# Addendum 05

**Date: April 22, 2025**

## **STOCKTON UNIFIED SCHOOL DISTRICT**

Expanded Learning Opportunities Program (ELOP) - Relocatable Classroom Buildings

DRAWING E710

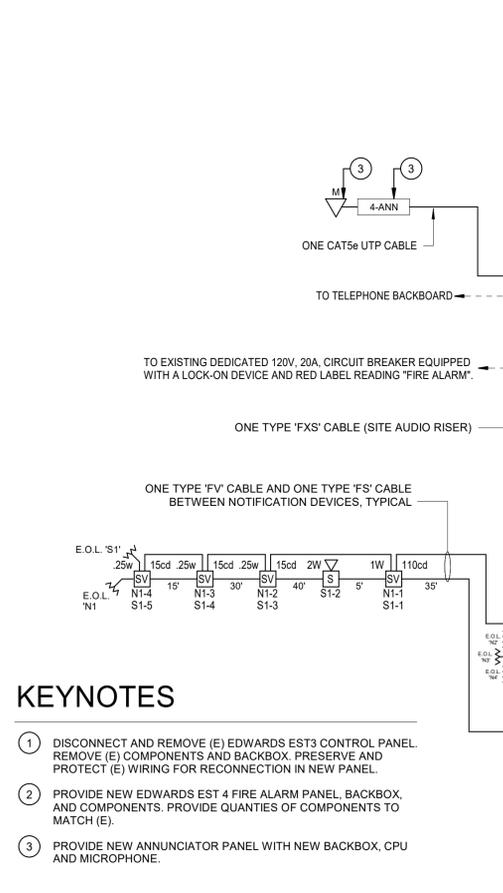
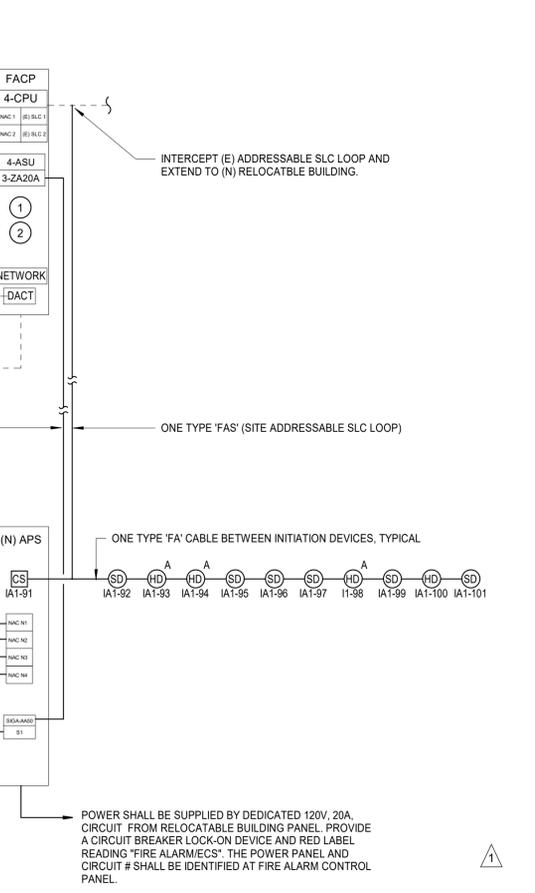
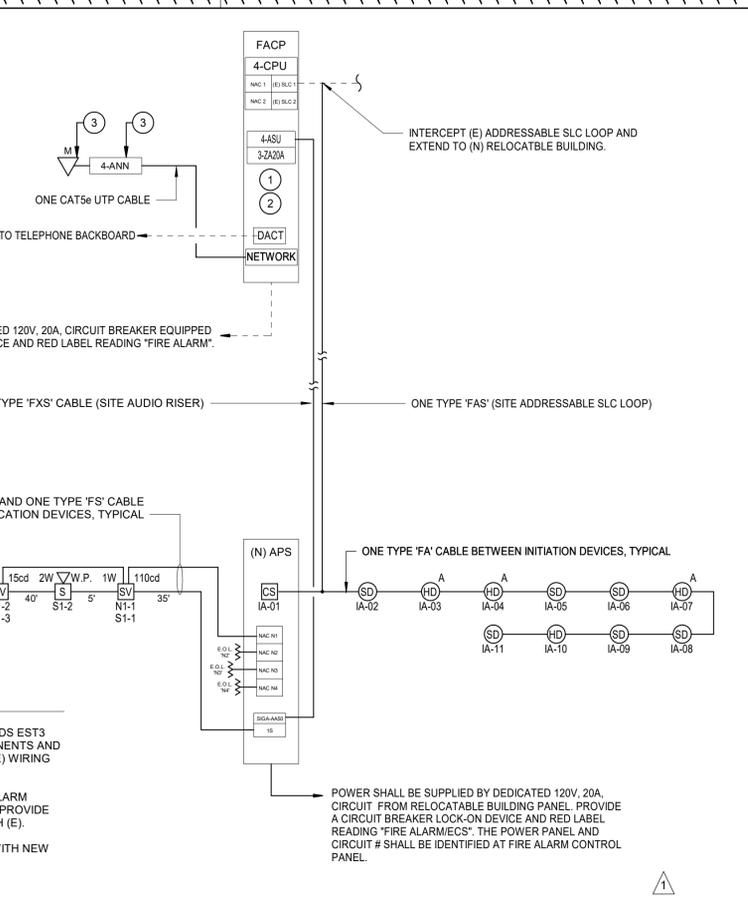
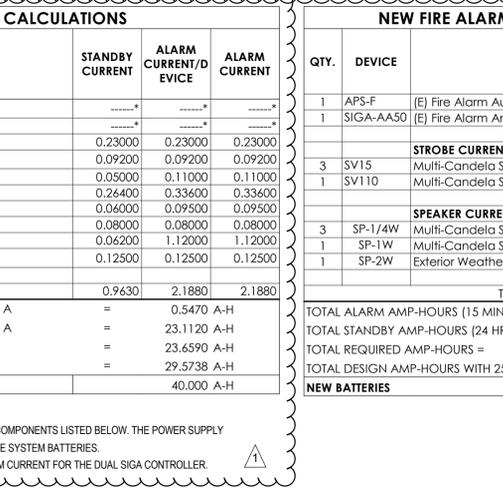
**5 - 03: DRAWINGS, SHEET E710 – “FIRE ALARM RISER DIAGRAM & CALCULATIONS”**, revise as follows:

- A. Replace sheet for sheet within the bid documents with the attached sheet in its entirety. Please note changes as clouded.
  - 1. Revised fire alarm control panel and components to replace obsolete Edwards EST 3 with updated Edwards EST 4 Emergency Communications Platform. See attached, **AD5-TAY-E01**.

PROJECT NO.  
 23-12907.00  
 DRAWING  
**E710**  
 AD5-ROO-E03

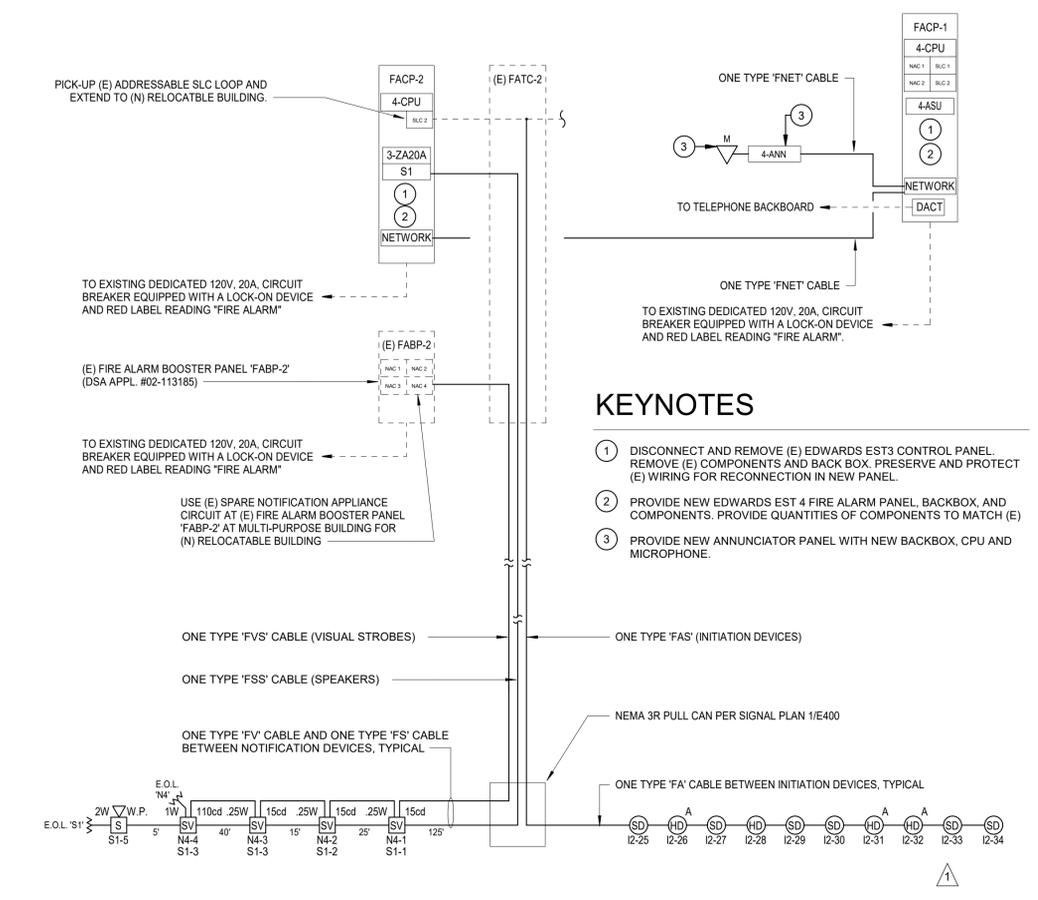
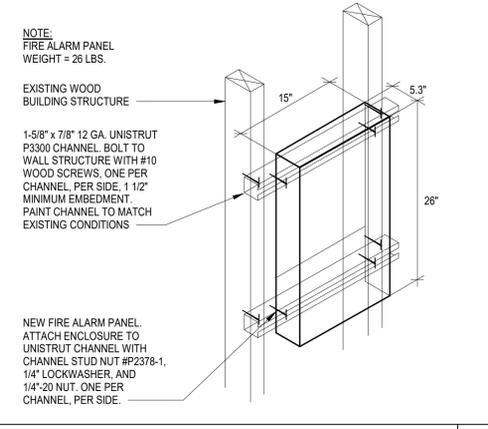
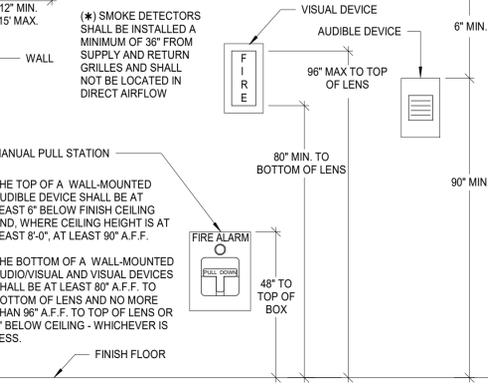
**5 - 05: DRAWINGS, SHEET E710 – “FIRE ALARM RISER DIAGRAM & CALCULATIONS”**, revise as follows:

A. Replace sheet for sheet within the bid documents with the attached sheet in its entirety. Please note changes as clouded.

1. Revised fire alarm control panel and components to replace obsolete Edwards EST 3 with updated Edwards EST 4 Emergency Communications Platform. See attached, **AD5-ROO-E03**.

PROJECT NO. 23-12909.00  
DRAWING E710  
AD5-RIO-E05

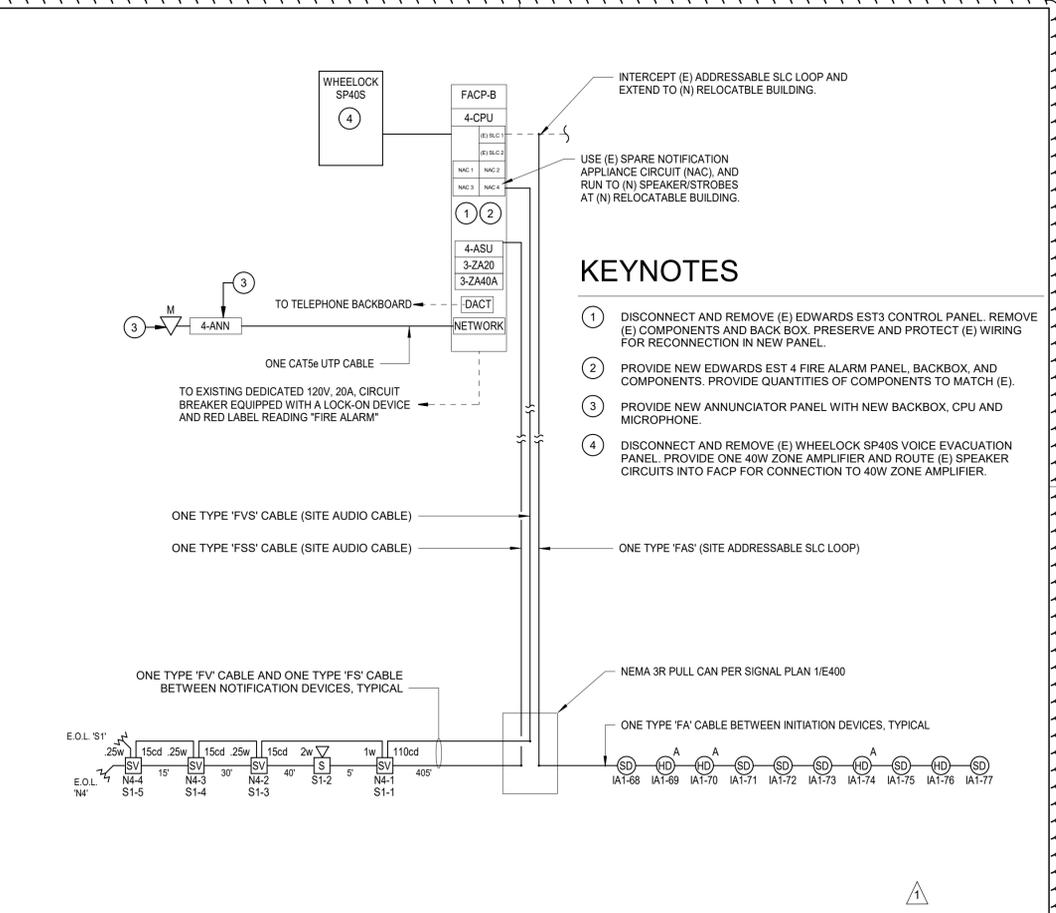
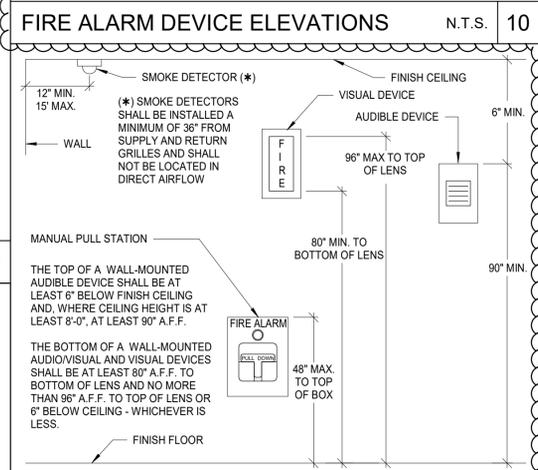
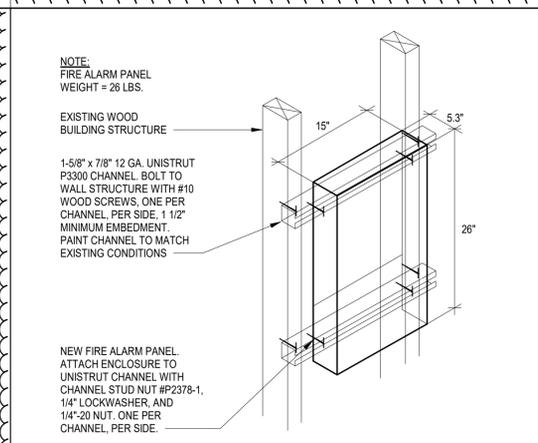
**5 - 07: DRAWINGS, SHEET E710 – “FIRE ALARM RISER DIAGRAM & CALCULATIONS”,** revise as follows:

- A. Replace sheet for sheet within the bid documents with the attached sheet in its entirety. Please note changes as clouded.
  - 1. Revised fire alarm control panel and components to replace obsolete Edwards EST 3 with updated Edwards EST 4 Emergency Communications Platform. See attached, **AD5-RIO-E05**.

PROJECT NO. 23-13018.00  
 DRAWING E710  
 DRAWING TITLE FIRE ALARM RISER DIAGRAM & CALCULATIONS

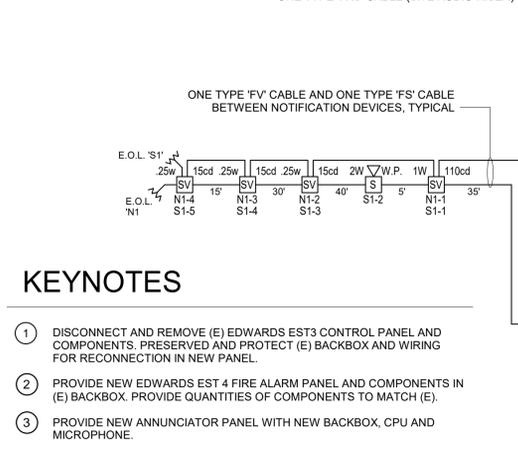
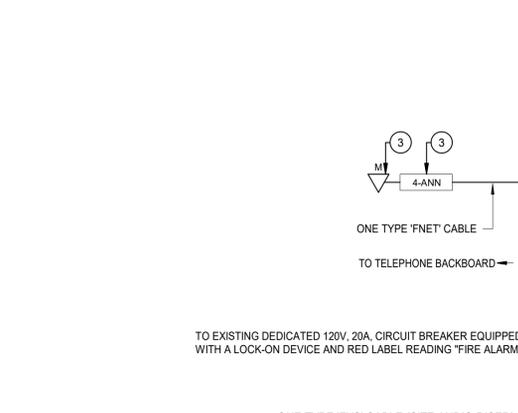
**5 - 08: DRAWINGS, SHEET E710 – “FIRE ALARM RISER DIAGRAM & CALCULATIONS”,** revise as follows:

- A. Replace sheet for sheet within the bid documents with the attached sheet in its entirety. Please note changes as clouded.
  - 1. Revised fire alarm control panel and components to replace obsolete Edwards EST 3 with updated Edwards EST 4 Emergency Communications Platform. See attached, **AD5-HAM-E06**.
